**4. Deletion of Floor Area Bonus System –21.04.020**

**ISSUE:**

(1) The bulk of a building relative to the size of its lot is measured as floor-area-ratio: the amount of floor area in the building compared to the area of the lot. The figure below shows an “FAR” of 1.

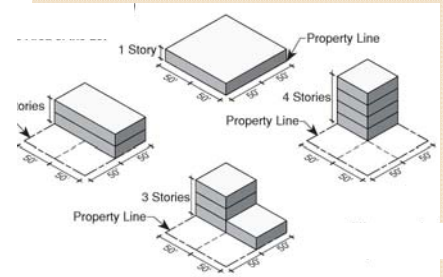
- The old and new maximum allowed building bulk is a “floor-area-ratio” of **2 in the above districts**. (See 1.) This maintains a reasonable building scale relative to the size of its lot and setbacks, and intended neighborhood character.

**4. Deletion of Floor Area Bonus System (Continued)**

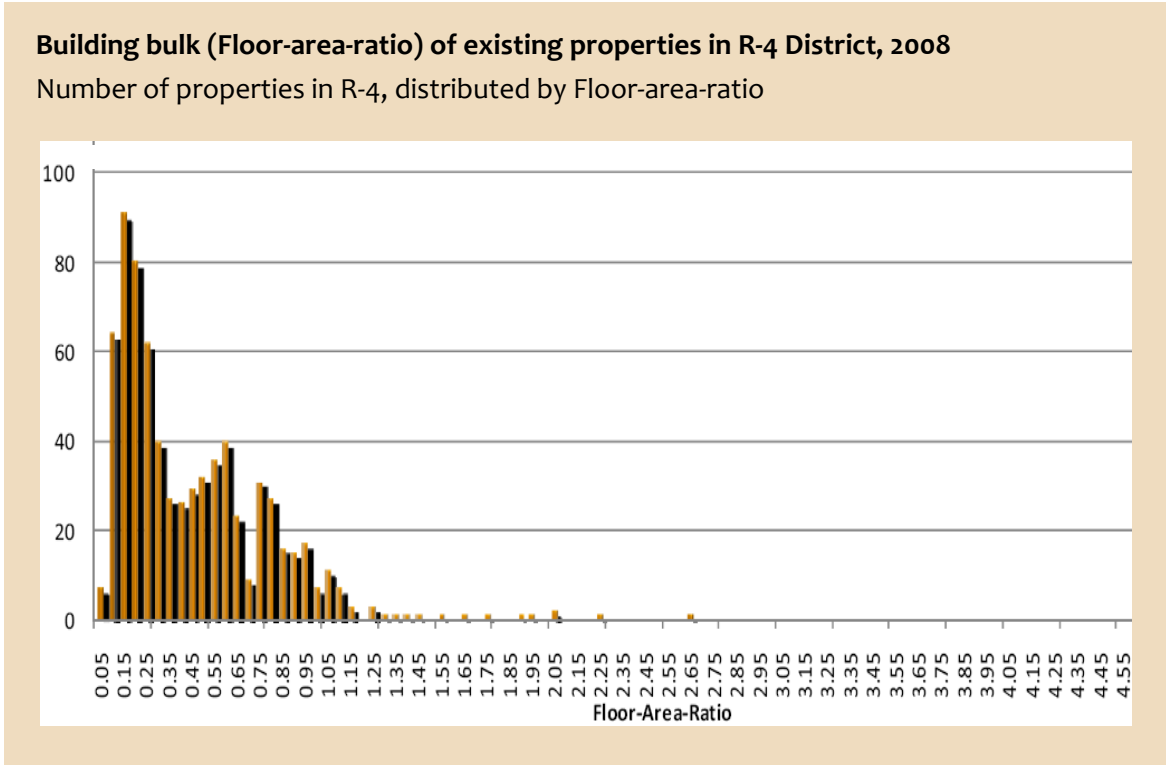
- The FAR bonus system allows for more than typically built. Few properties achieve even 1 FAR, as illustrated on the next page.
- Park Plaza II apartments at 16th and A is one of the highest density projects in recent decades. It incorporates two levels of structured parking, yet its FAR of 1.89 still falls below the maximum allowed bulk. (See 2.)

Retain the bonus system for earning maximum allowed FAR, with a by-right 1.5 FAR in all districts.
